Action Items from the October 30, 1996 DOE/NSF Review

US CMS Collaboration

January 15, 1997

HCAL, Review and L2

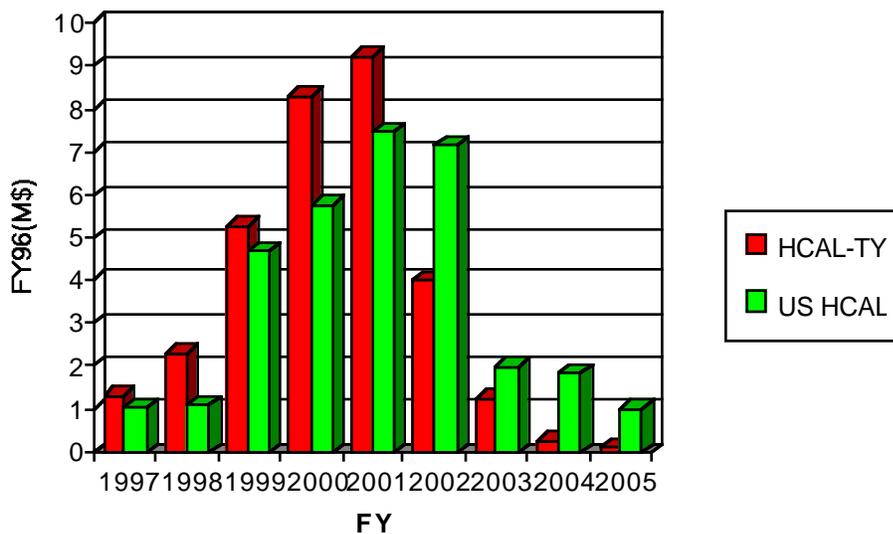
- Given the following tentative funding profile, develop a plan for a set of deliverables with a consistent cost profile and which is compatible with the CMS schedule.

To the L2 milestones we plan to attach WBS items using MS Project and the Resource Sheet. WBS numbers are indicated in the HCAL L2 milestone figure. The costs given in the Resource Sheet are then loaded into the L2 schedule. That allows the L2 cost profile to be derived. A first rough cut at the HCAL cost profile has been derived and is compared to what was presented at the October 30 joint DOE/NSF review.

The finer segmentation of HCAL into specific HB, HE and HF costs attached to the US CMS responsibilities leads to differences. In addition, the iteration in planning, in particular a deferral of higher level HCAL trigger and DAQ electronics and of HF to the last possible moment, leads to a more back end loaded cost profile in this latter exercise. We will continue to attempt to match the cost profile to the given funding profile.

The US CMS Management Board is thus in train to produce a resource loaded integrated cost and schedule in time for the June, 1997 "Lehman Review". Our plan and methodology are in place and an example using the HCAL subsystem is shown graphically here. It appears that a cost profile which better matches the funding profile is indeed possible.

US CMS Cost Prc

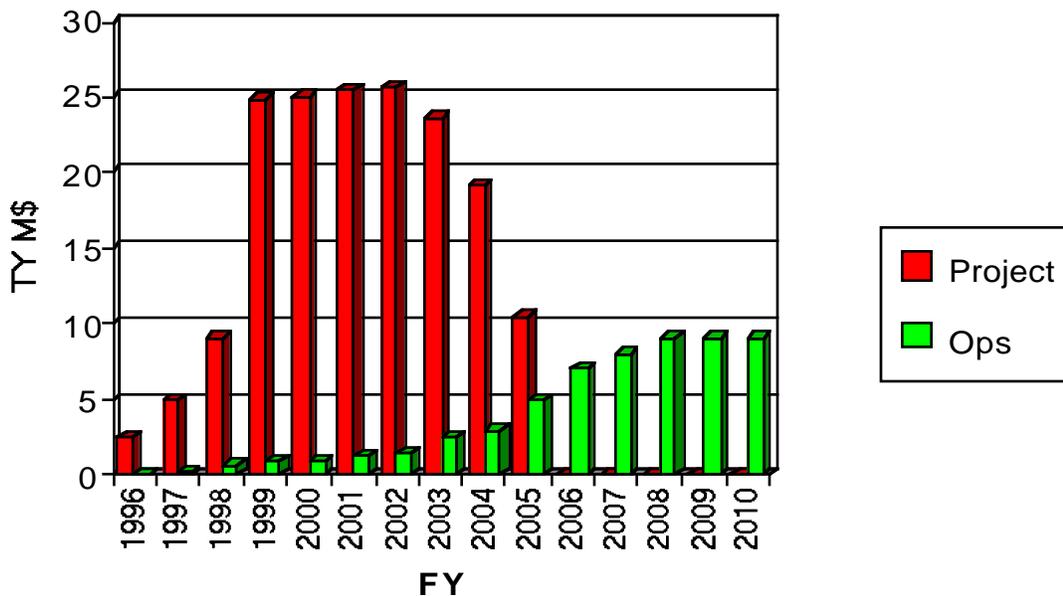
- **Develop a plan for incremental operating costs during and after the period of detector construction including computing, operating costs, and incremental needs.**

Based again on LEP experience, we then expect a sharp ramp-up of operating expenses for 2-3 years prior to first beam. Note that this corresponds to the time when the detector elements are first installed in the underground Collision Hall, which makes sense from a scheduling viewpoint. We estimate that the computing costs will reach a level of 5M\$/year, scaling from LEP experience and again applying existing standards of support by DOE.

We note that we are requesting nothing in excess of existing levels of support. In fact, it can be argued that US CMS is a particularly good deal. The collaboration will not need to pay for operation of the LHC. Therefore, assuming that US HEP is supported at a level of 650 M\$, scaling to 15% of all US HEP experimentalists would argue that US CMS should receive 97 M\$/year. Our incremental
